DEVIATION REQUEST AND DECISION FORM

Project Name :	Crossroads Mixed-Use Preliminary Plan
Schedule No.(s) :	5408007005
Legal Description :	A portion of Tract B 24/94 Business Park Fil No. 1, as amended by affidavit of correction rec. #219097386

A deviation from the standards of or in Section **2.3.7.E.1 & E.3 and Table 2-25** of the Engineering Criteria Manual (ECM) is requested.

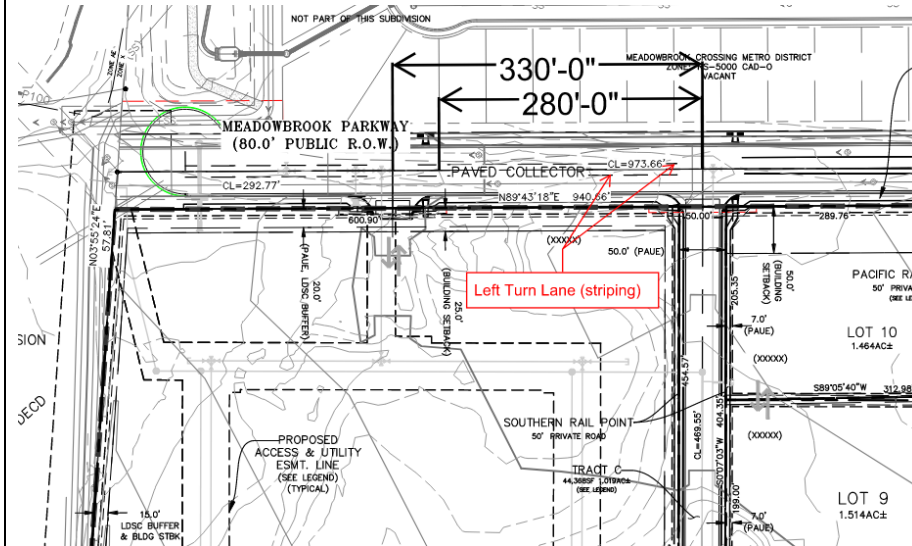
Update. Insufficient reason is provided. The "West" driveway can be shifted to the west so the left turn lane meets criteria.

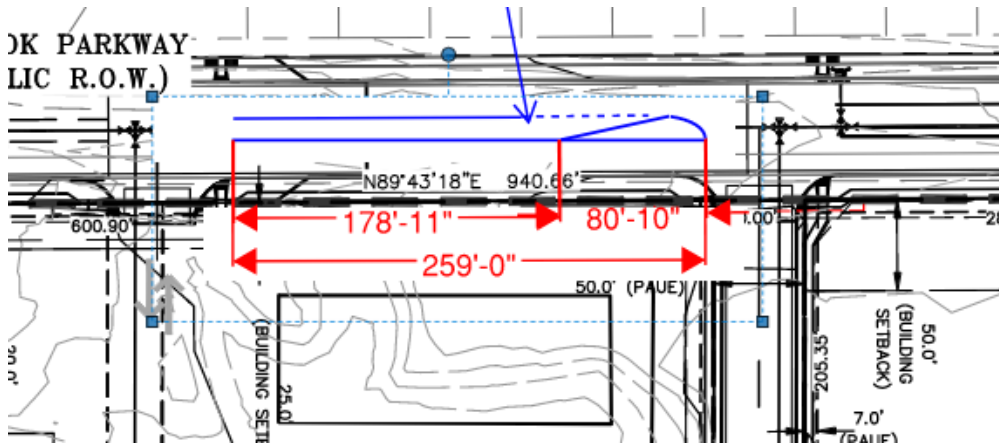
Separate the 180' lane to its individual components (storage & lane length)

Based on the rough layout sketch below, the proposed turn lane striping would not fit without extending into the intersection which could conflict with the turn movements at the middle access location. Provide a larger exhibit (to scale) showing the proposed striping configuration.

Are there any regional or national standard such as CDOT Access Design Guide Section 9.17 or AASHTO that can be applied for the required turn lane?

Provide supporting analysis that there won't be any issues with deceleration length (lane length plus taper length).
